DOCKET NOS. 50-266 AND 50-301 ADDITIONAL INFORMATION ATWS MITIGATING SYSTEM ACTUATION CIRCUITS (AMSAC) POINT BEACH NUCLEAR PLANT, UNITS 1 AND 2

### ATTACHMENT TO VPNPD-87-545 NRC-87-132 RESPONSE TO NRC REQUESTS FOR INFORMATION REGARDING AMSAC

#### 7. Logic Diagram

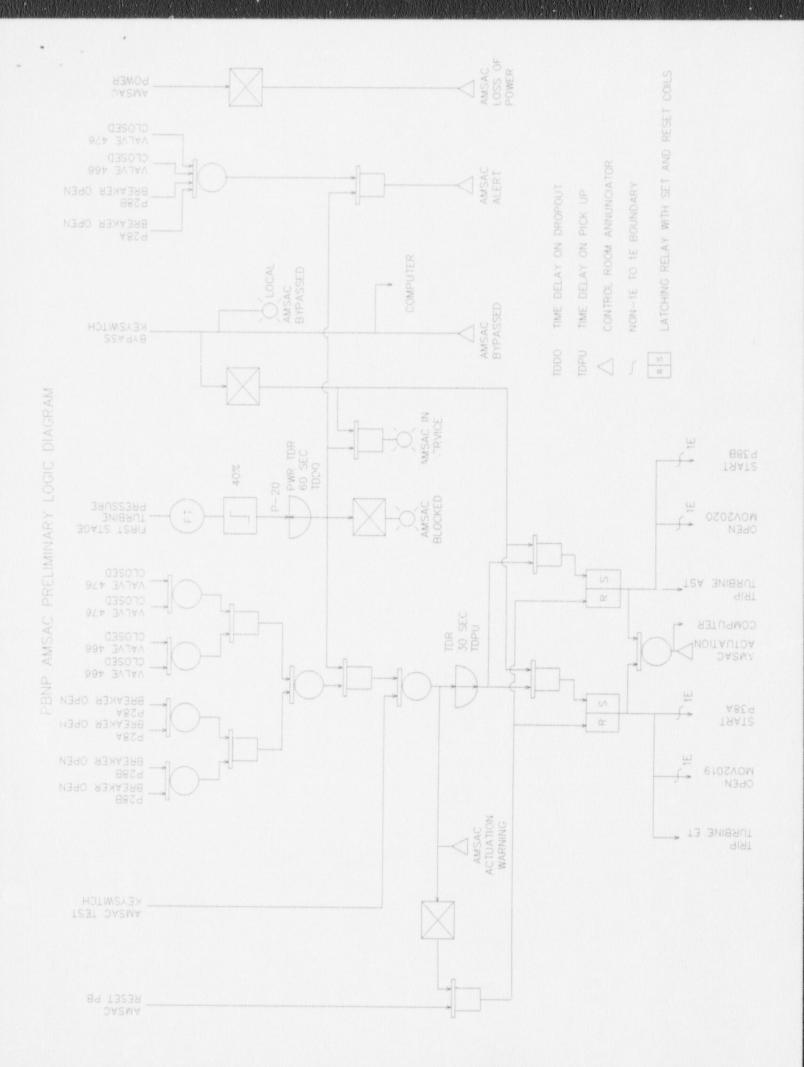
A logic diagram of the proposed AMSAC is attached. Also attached is a circuit diagram.

A test point (TP4) has been added to the circuit design between the PWR TDR contact and the logic matrix. The test point was added to allow verification of power to the logic matrix after cycling the PWR TDR relay.
